Regulators' Alliance for Progressing
Infrastructure Development

December 2021

Strategic regional water resource solutions: Standard gate one final decision for West Country South Sources and Transfers

Figure 2. Submission Assessment

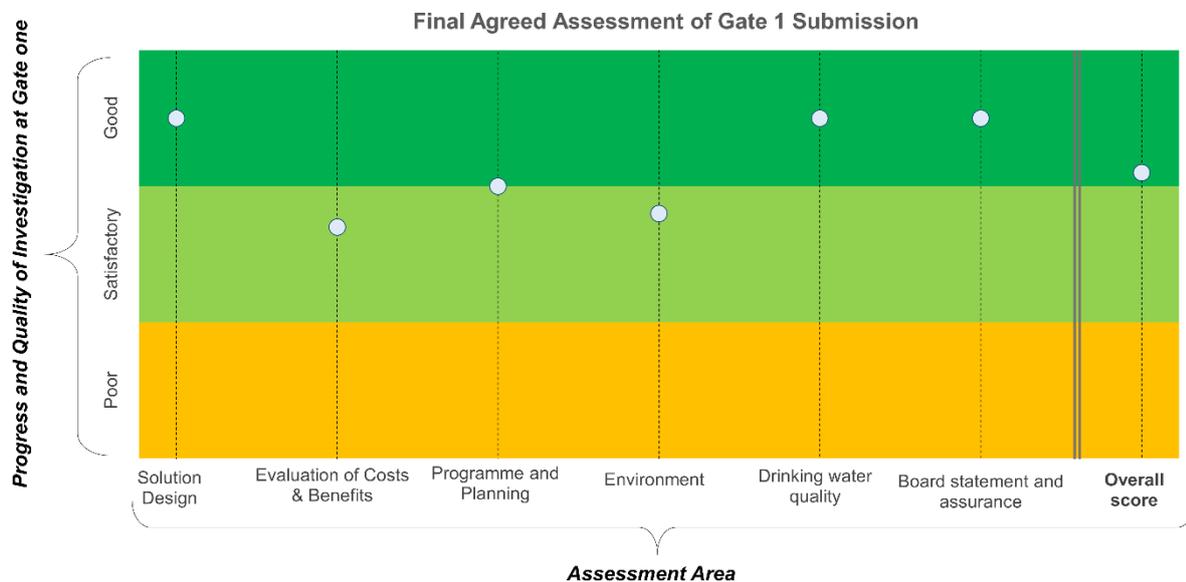
Our overall assessment for the solution submission is that it is good (meets expectations).

We consider that the progress and quality of the investigation completed by South West Water, Wessex Water and Southern Water in developing the solution design at gate one has

been good, although we expect to see this expanded upon with more detail in the gate two submission particularly regarding operational utilisation and engagement activities following the outputs of regional modelling.

We consider that South West Water, Wessex Water and Southern Water's evaluation of the costs and benefits of the solution for gate one is satisfactory but has fallen short of expectations in some areas including the development of a best value discussion comparing the options of this solution and assessment of deployable output of the solution under 1 in 500 drought resilience.

We consider that the progress and quality of the gate one investigation completed by South West Water, Wessex Water and Southern Water regarding the programme and planning, risks and issues and the procurement and planning route strategy for West Country South Sources and Transfers has been satisfactory at gate one but has fallen short of expectations in some areas including the assessment of whether elements of the scheme are eligible for Direct Procurement for Customers (DPC) and a need for openness to legal solutions to address regulatory barriers.

We consider that the progress and quality of the work presented in the gate one submission provided by South West Water, Wessex Water and Southern Water regarding the environmental assessment, potential mitigations, future work programmes and embodied and operational carbon commitments has been satisfactory but has fallen short of expectations at gate one in areas relating to environmental risks and mitigation, the programme and monitoring plan and the option level environmental assessment. Carbon methodologies could also be clarified.

We consider that the information provided in this submission on drinking water quality risks, stakeholder engagement and DWSPs for gate one was good, falling slightly short in terms of the breadth of the Poole sewage treatment works risk assessment and consideration of the impact of influent on the treatment process or inclusion of a failsafe shutdown on the effluent discharge. We expect to see further development of DWSPs, water quality monitoring, including for emerging contaminants, and wider stakeholder engagement with ongoing dialogue with the respective water quality teams in gate two.
